PLANNING BOARD MEETING AGENDA

June 26, 2024 at 7:30 PM

Re: Wickes Arborists – 11 McNamara Road
Response to Site Plan and Special Permit Review comments

The following are in response to comments prepared by Brooker Engineering, PLLC dated May 23, 2023.

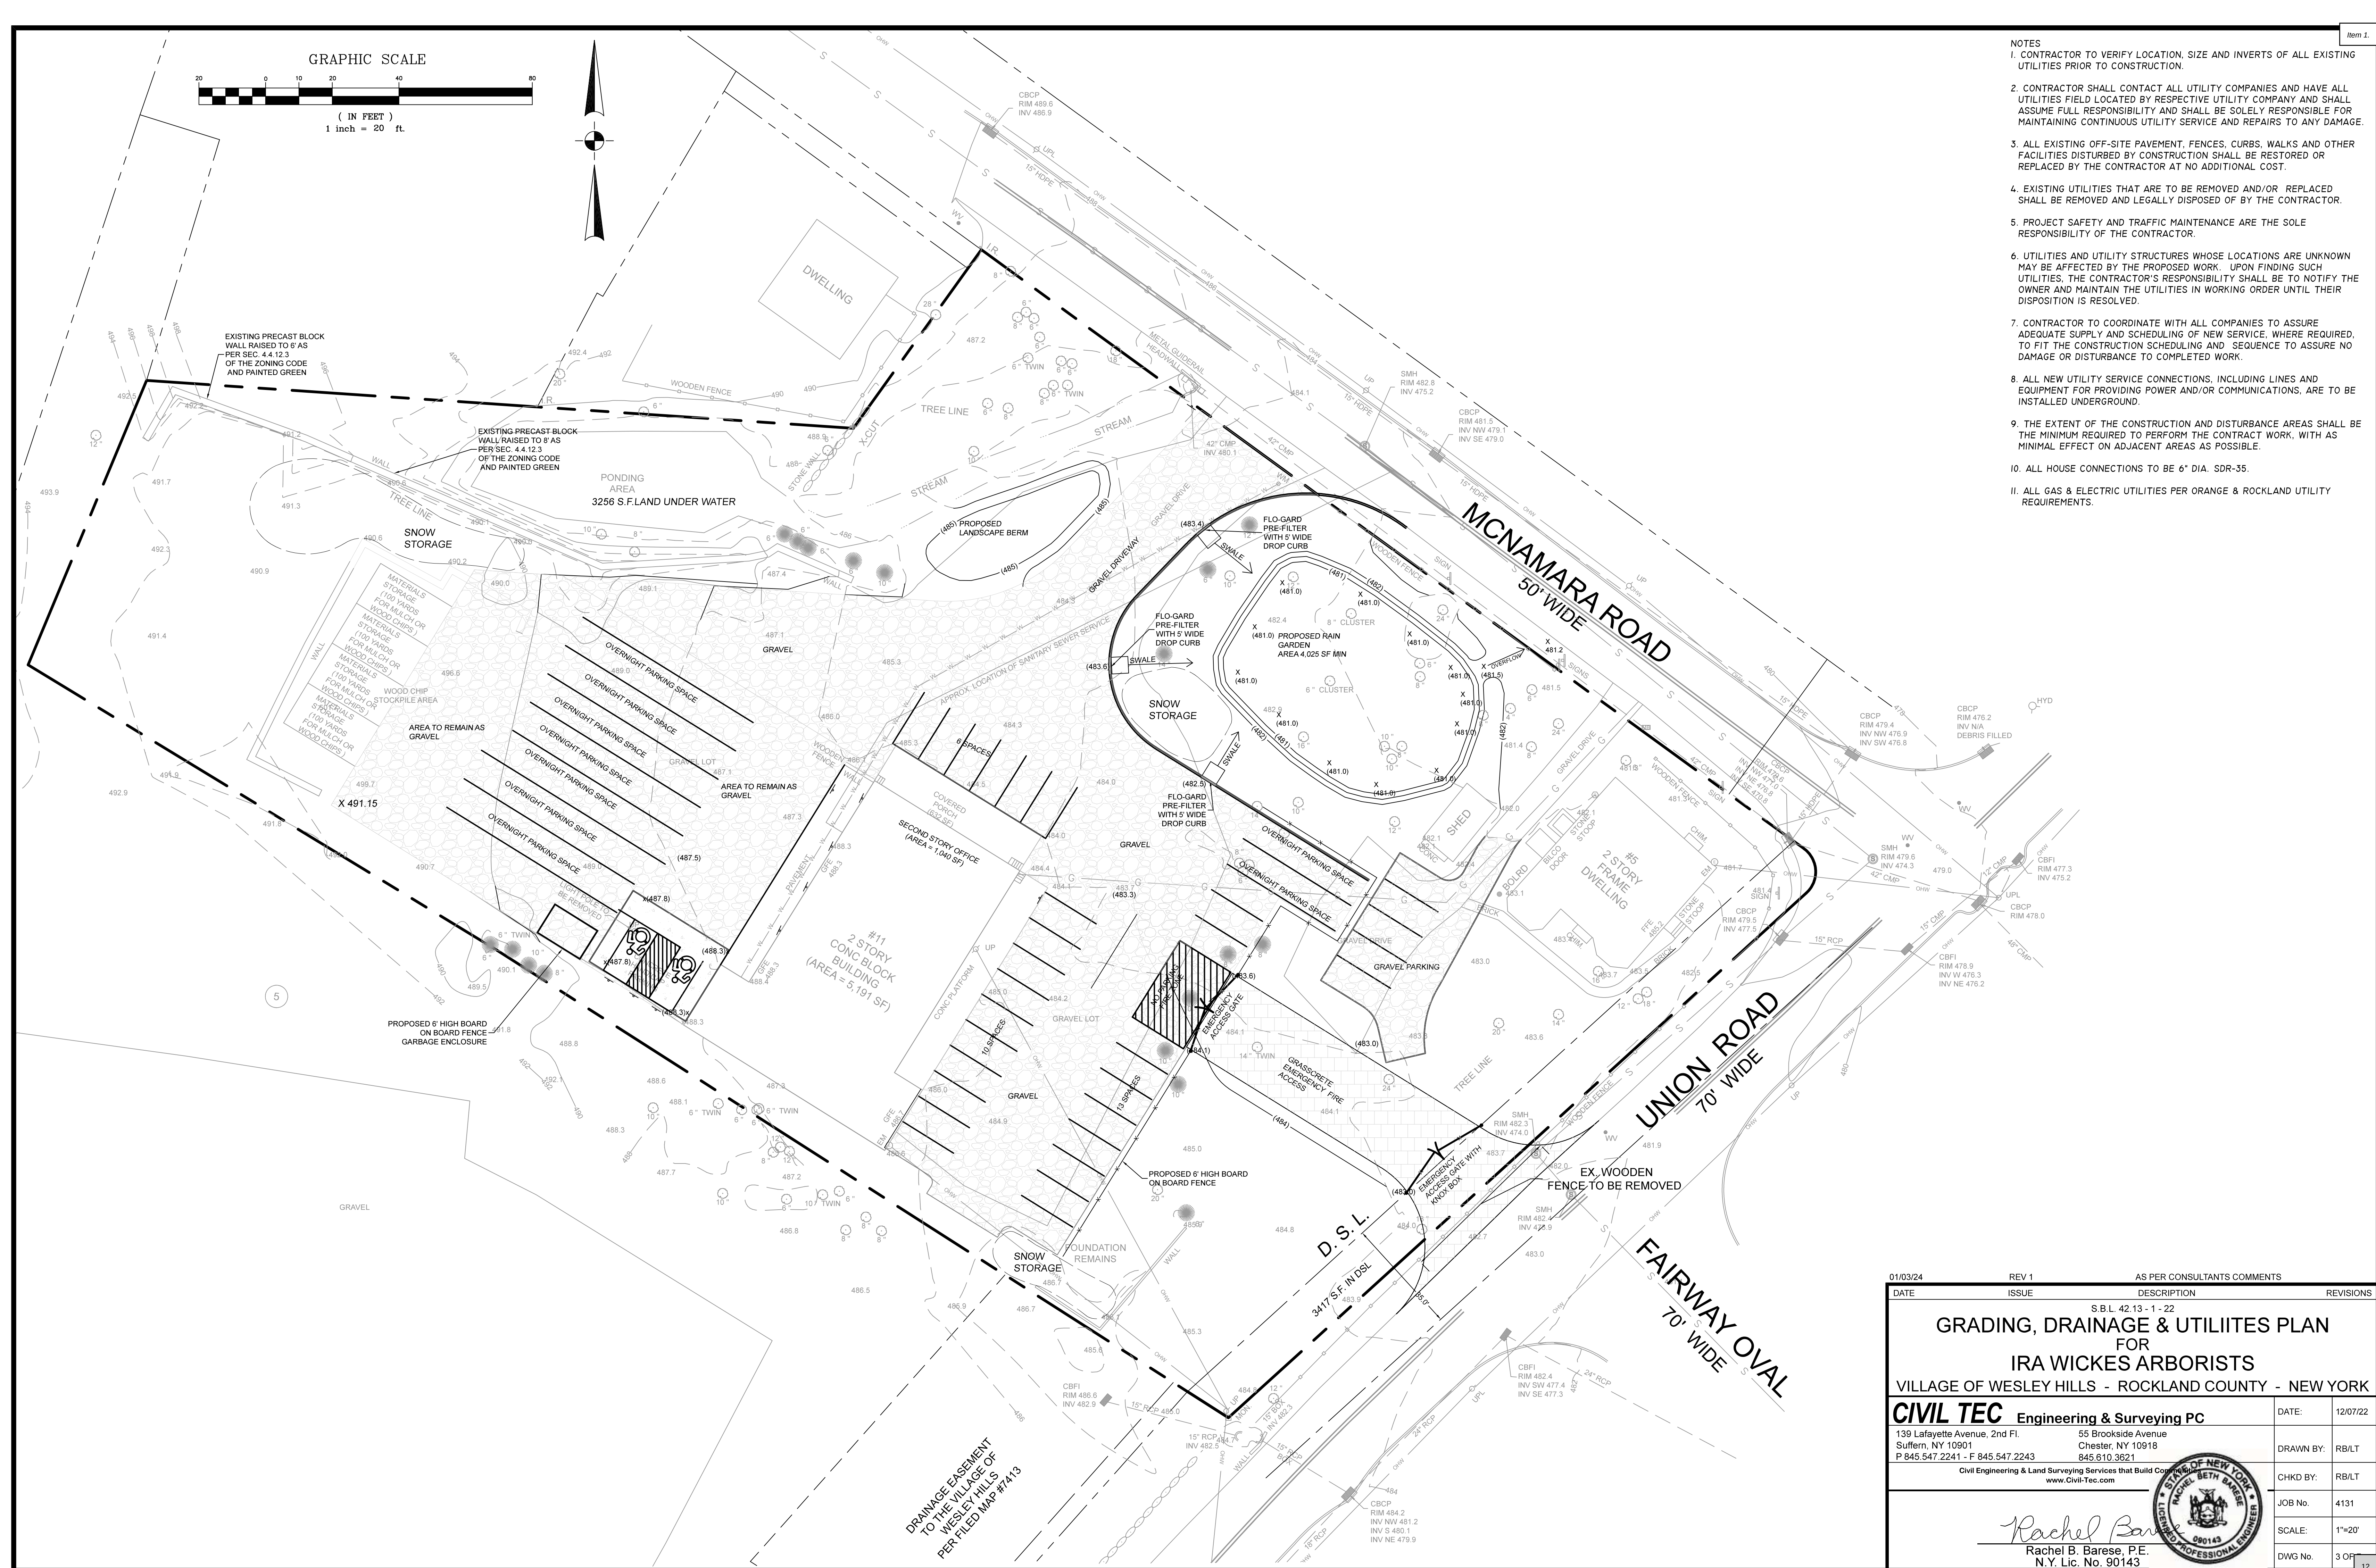
- 10. Grading detail is limited. Additional spot grades shall be provided to demonstrate:**

- 11. Additional drop curbs appear necessary to accommodate proposed configuration of catch basins/flo-gard prefilters. Outlet of catch basin to be clarified. Detail suggests a piped overflow is needed. Grading/inverts to be confirmed.**

- 13. The discharge point for the underdrain system and domed overflow riser are absent from the plan. Overflow invert, underdrain invert, and discharge location & invert shall be provided.**

Response: Additional spot grades have been provided to clarify the proposed grading in the named areas.

Response: An additional Drop curbs and an additional flo-gard pre-filter have been proposed. The overflow has been designed to flow overland in a grass swale to McNamara Road drainage system. An underdrain is not required in the rain garden if the soil infiltration rate is not sufficient. If soil testing determines an underrating is required, we will design it before construction.

Response: Overflow has been designed to flow overland in a grass swale to McNamara Road drainage system.

GRASSCRETE PERVIOUS PAVEMENT DETAIL

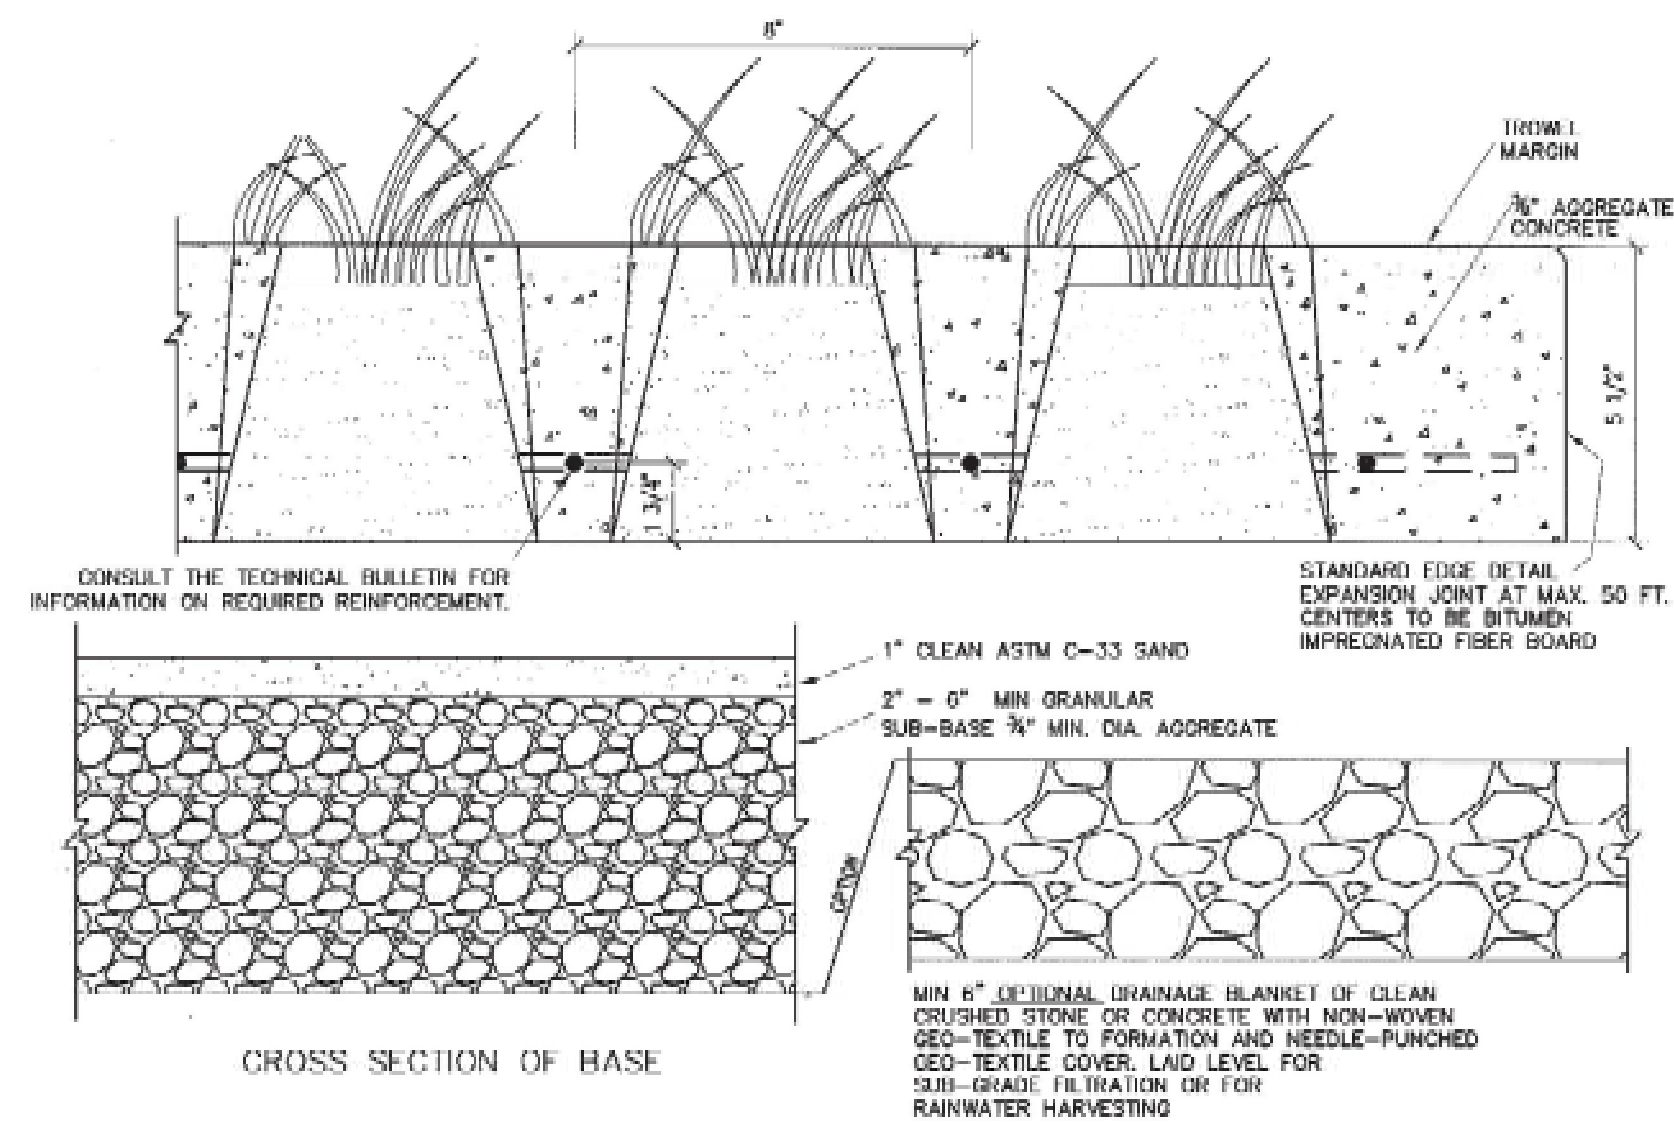
- 16. Grass-crete detail/cross section to be provided.**

Response: Additional Details have been provided.

CONCRETE CURB DETAIL

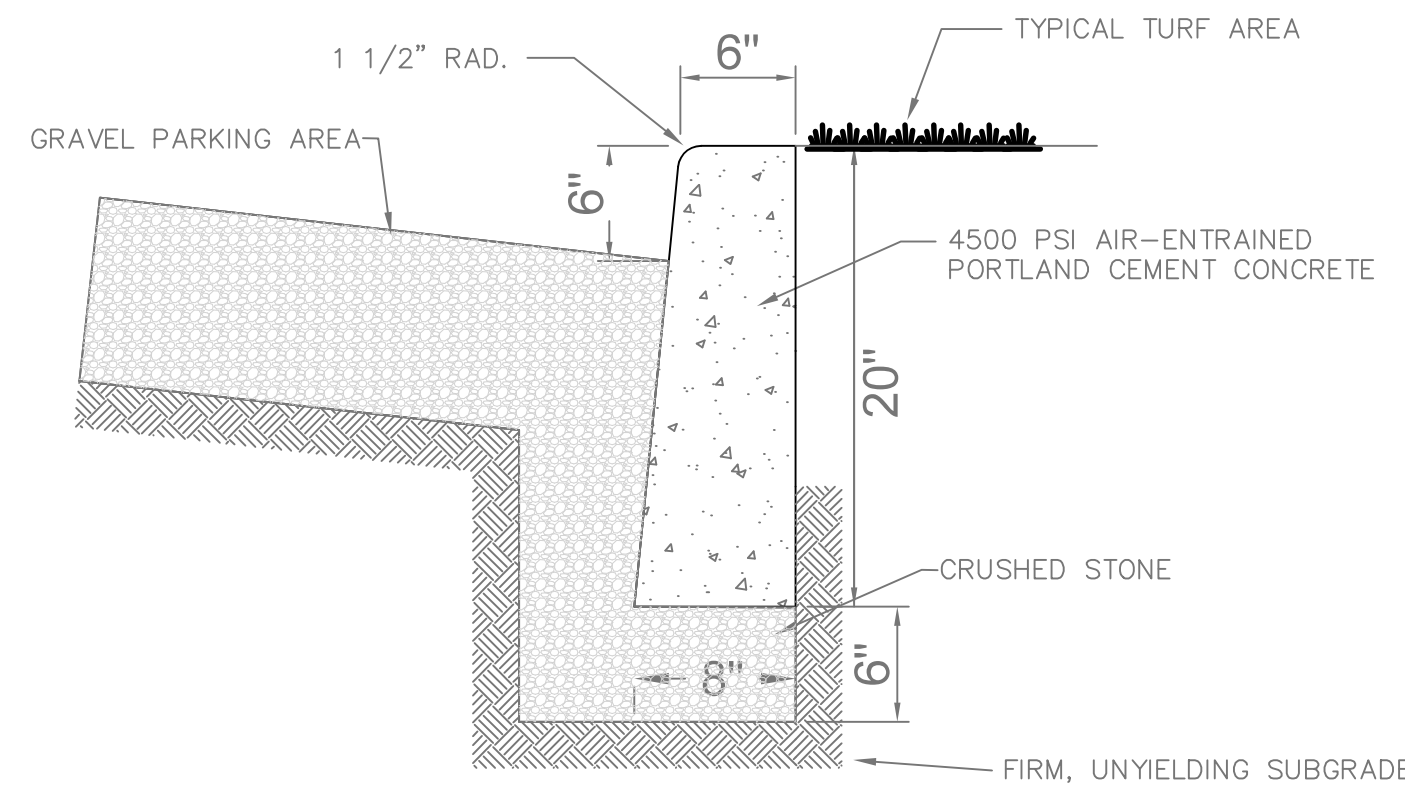
- 6. Proposed concrete curb limits to be confirmed. Previous plan set included only a limited area of concrete curb along the border of the rain garden to convey and pretreat stormwater runoff.**

Response: The Concrete curb is to be installed along the border of the rain garden to channel the flow into the rain garden through the pretreatment structures. The remaining concrete curbing has been removed.

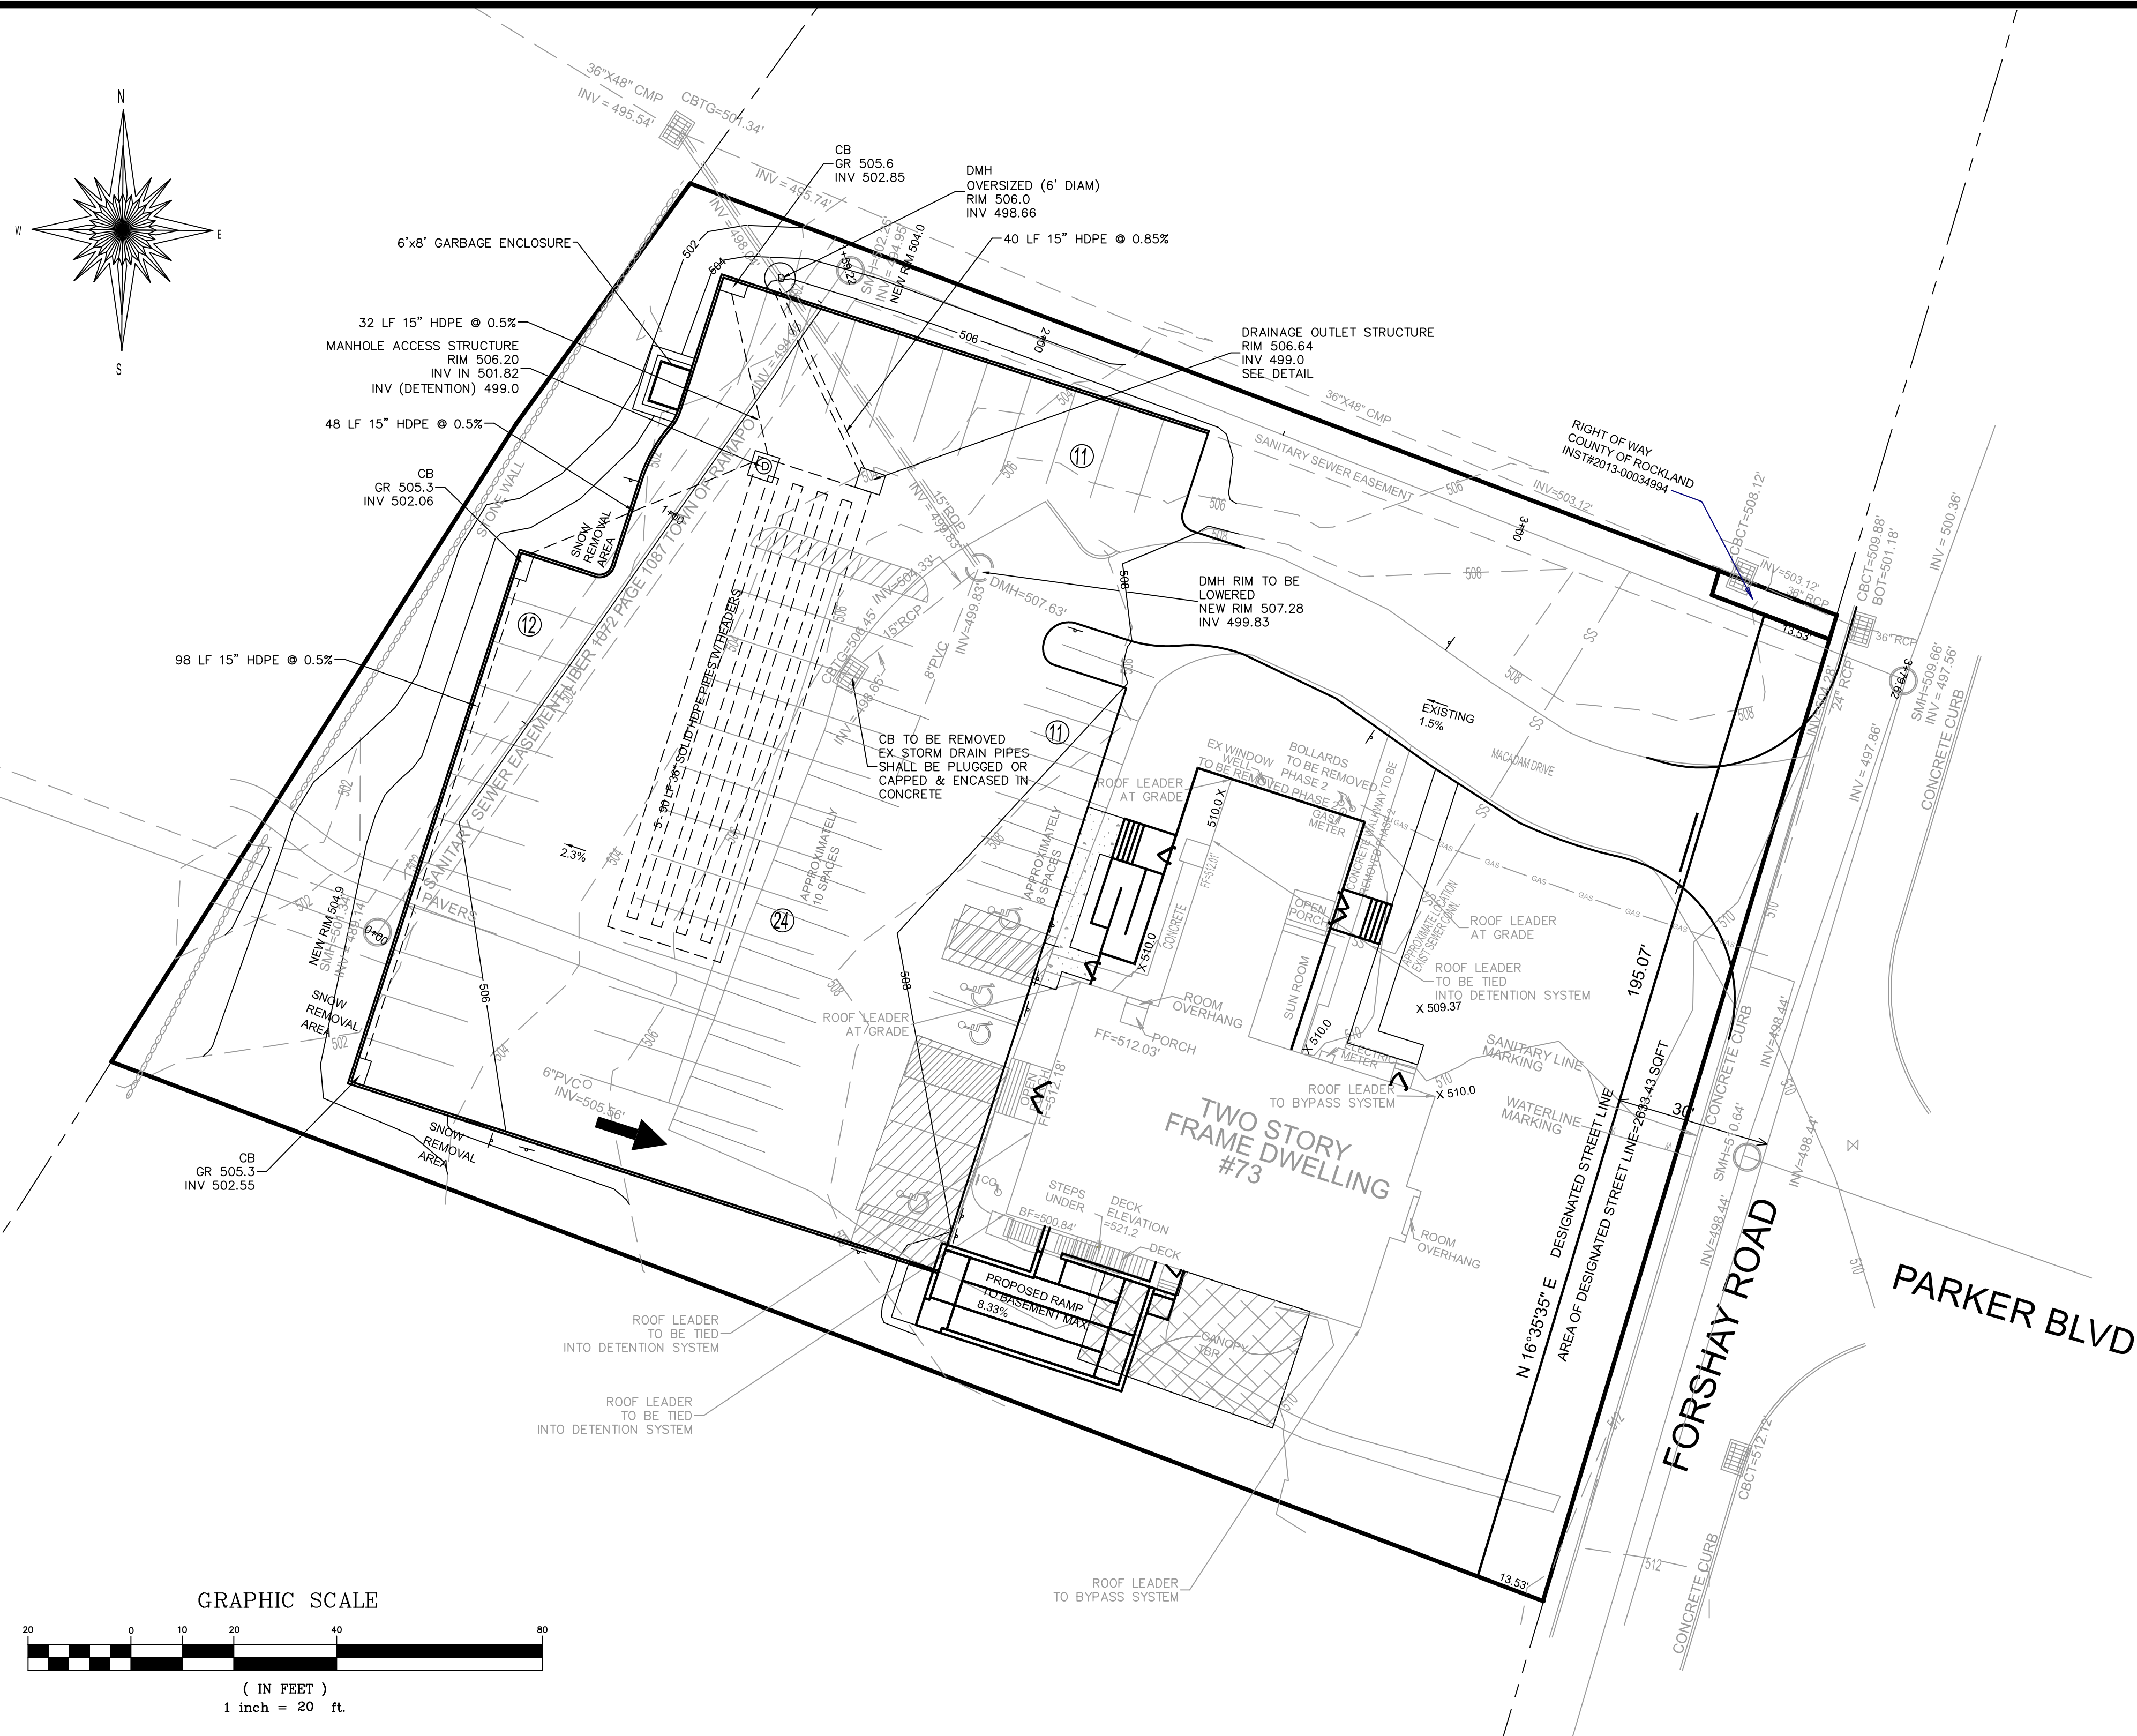
11. **To help reduce the impact of this development, a reduction of impervious surface should be considered. The amended Site Plan Phase 2 (Drawing 5 of 9) indicates that pervious pavers are proposed to be used for a patio at the southern side of the structure. It is recommended that porous pavers or porous concrete be considered to replace the use of conventional asphalt in additional areas of the site, as well. If installed correctly and properly maintained porous pavers have been shown to be effective in helping manage off-site runoff of stormwater. In addition to permeable pavers, other green infrastructure techniques should be considered such as bioswales, rain gardens, and rainwater capture. For long term effectiveness of permeable pavers and other green infrastructure techniques it is recommended that the Village and the applicant review Chapter 5 'Green Infrastructure Practices' of the 2015 NYSDEC Stormwater Design Manual. Based on the ground water, pervious pavers are no longer proposed.**
